Statement of Amendment.

Project: Pacific House

Project No: 21.689

Revision: P2

Proposed Plan: 21.689_P1_Proposed Front Elevation

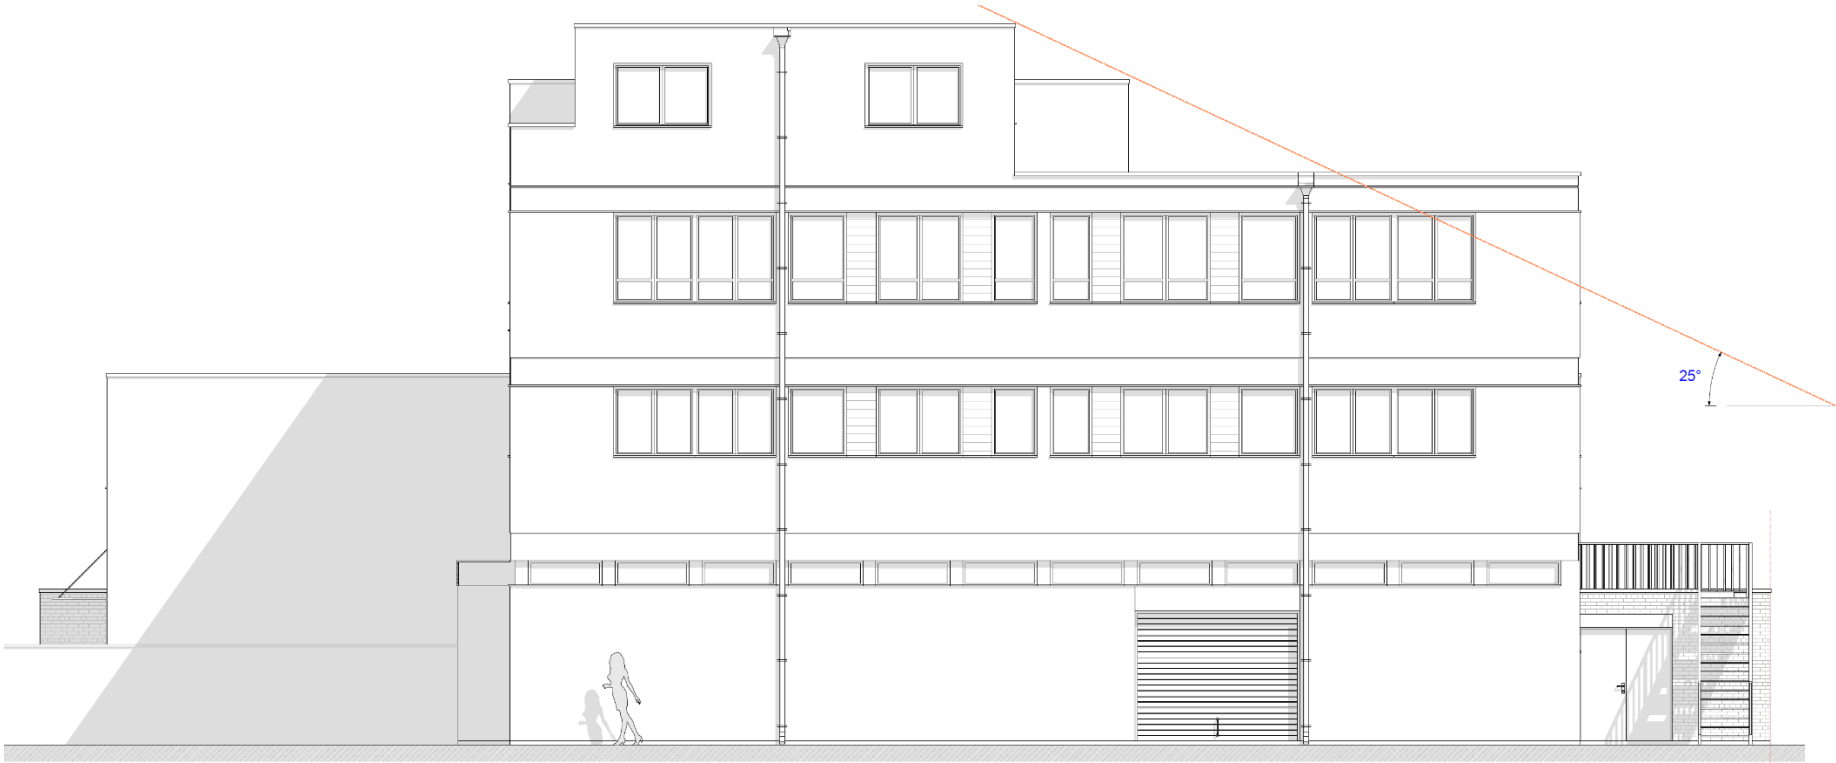
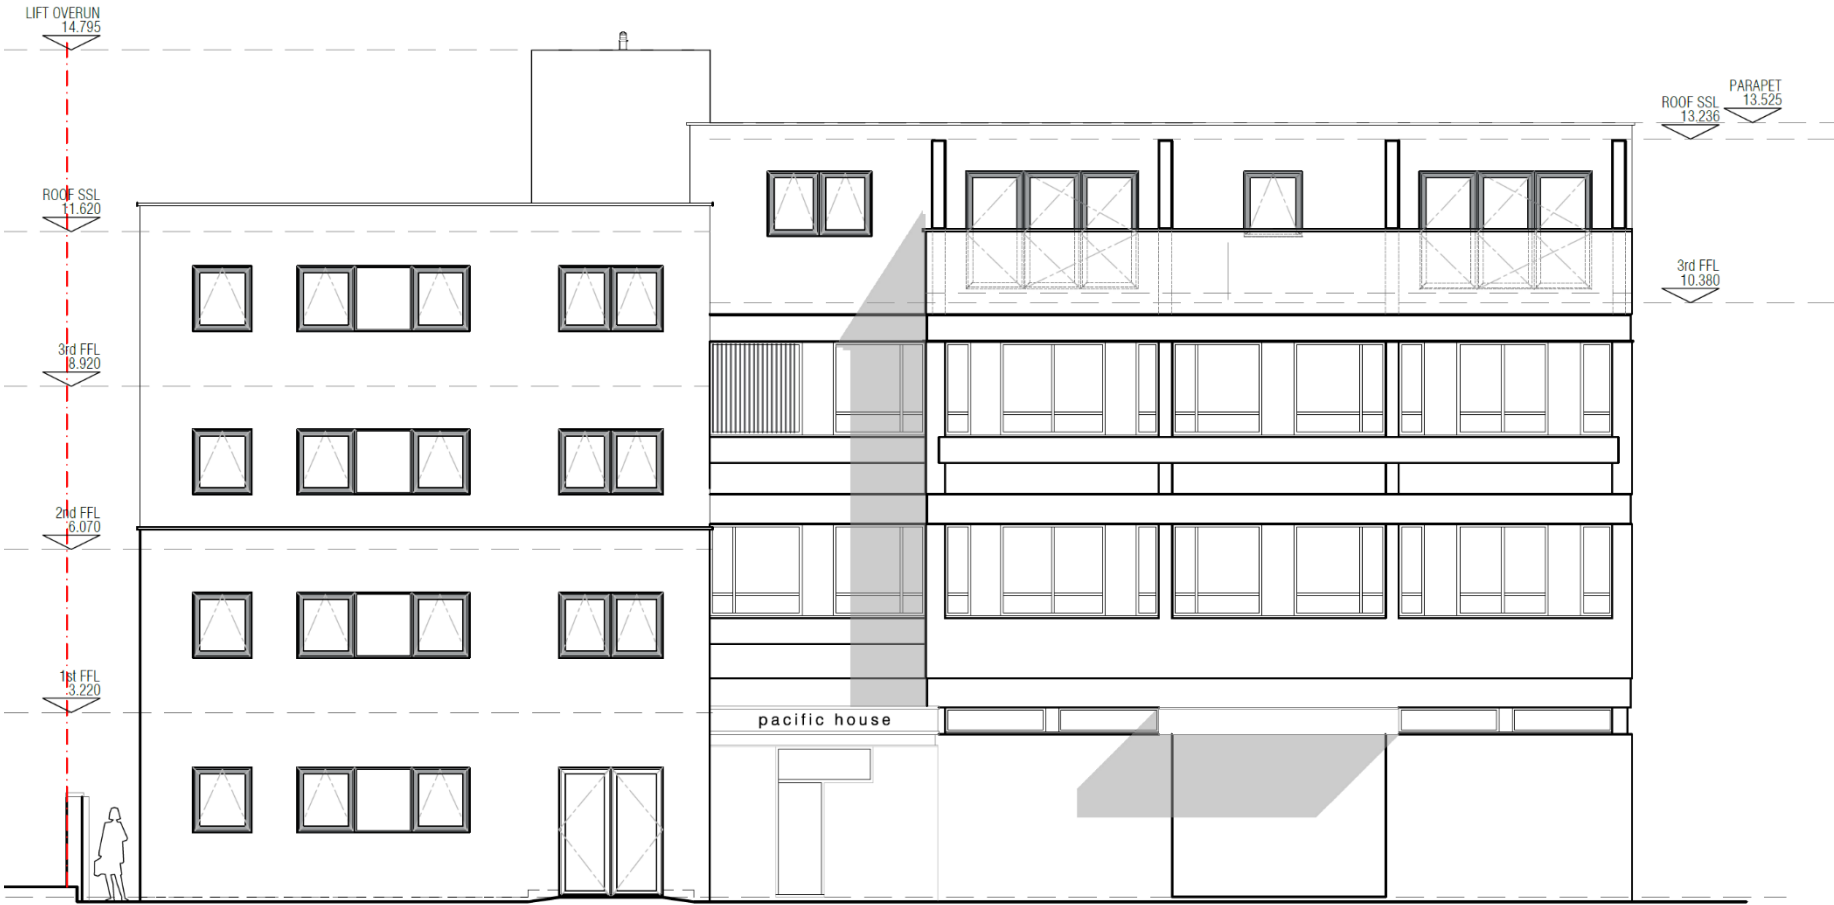
The approval shows an overall height of 13.2m for the vertical extension above the existing part of the building on the elevations. There is conflicting information within the consented sections though that states a height of 3.8m.

The proposed height of the vertical extension has been altered due to construction issues that have arisen. To ensure that the existing building is not impacted negatively by the additional extension, it has been rationalized in a way that increases the consented height.

Proposed Plan: 21.689_P1_Proposed Front Elevation

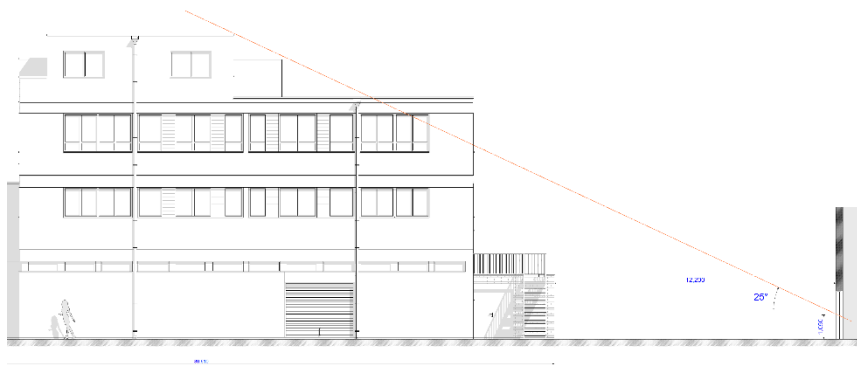
The original plans do not show any lift overrun as the need to be Part M compliant was not needed at this stage.

Due to the Part M compliant lift that is being installed an overrun is required, this increases the overall height of the building. This should not have a negative effect on the surrounding buildings.

Proposed Plans: 21.689_206_P1_Proposed Light Angles

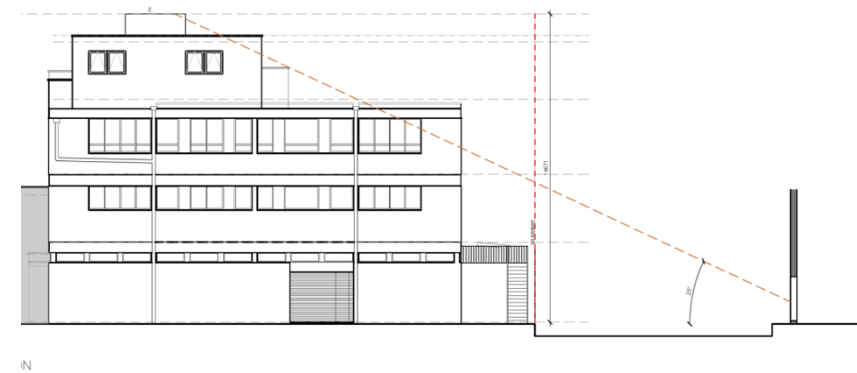
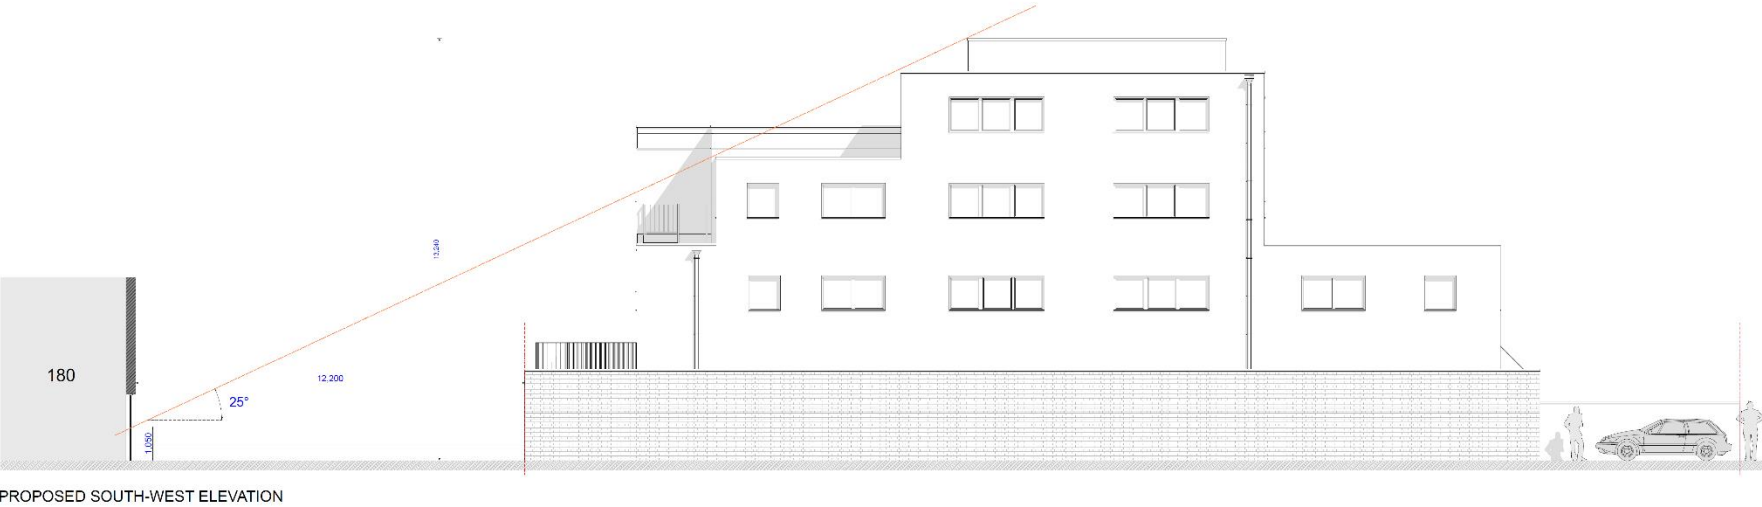
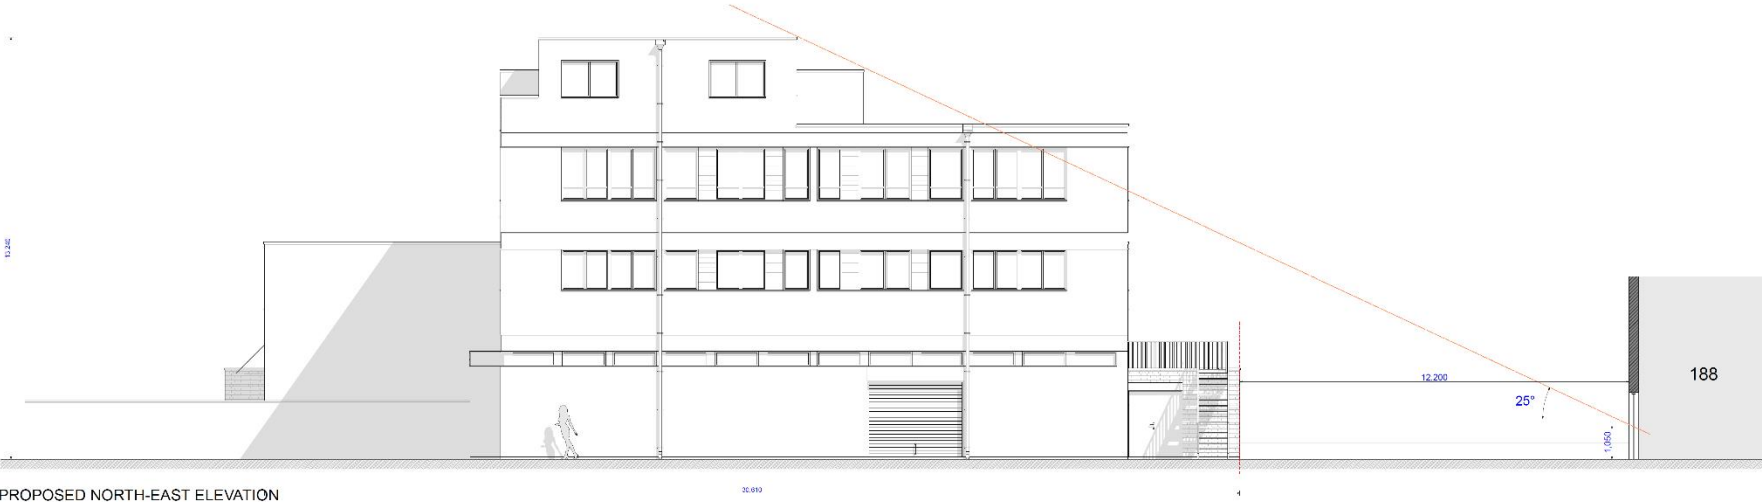
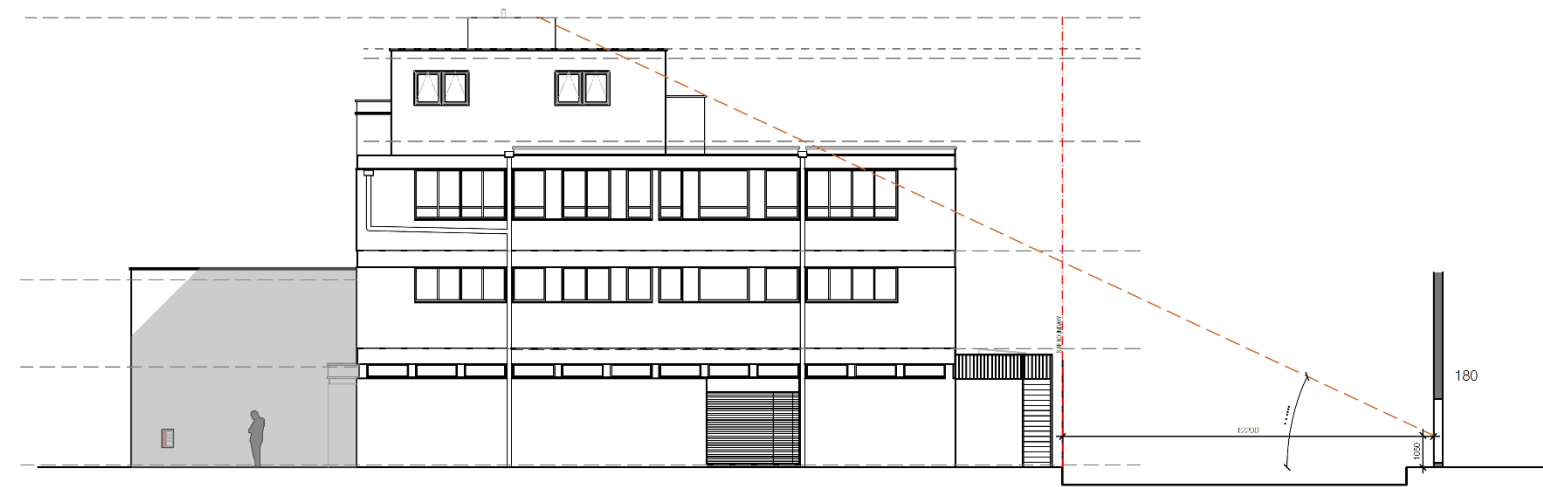
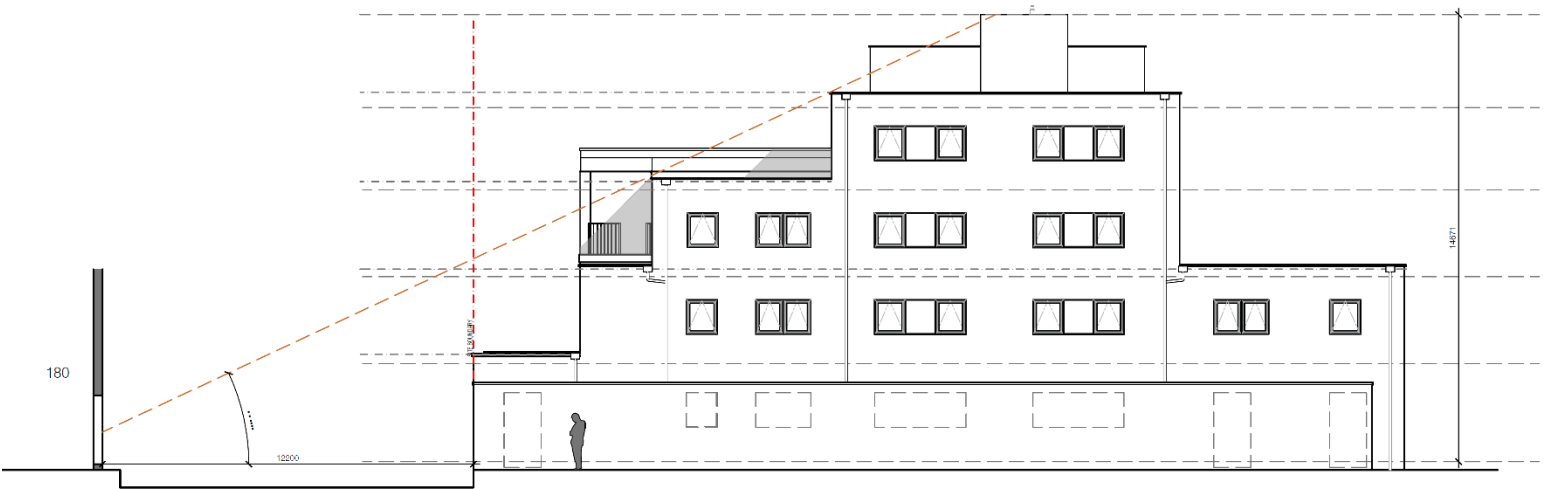
The consented application highlighted that there was no negative impact of the vertical extension as it would not be visible to the properties off of Hermitage Road as the existing building would block their view of it.

The proposed alteration in height does not effect the rear properties, just as the consented plans. The lift overrun is located in the central part of the building and therefore does not impact the surrounding buildings as the existing building blocks it from view.
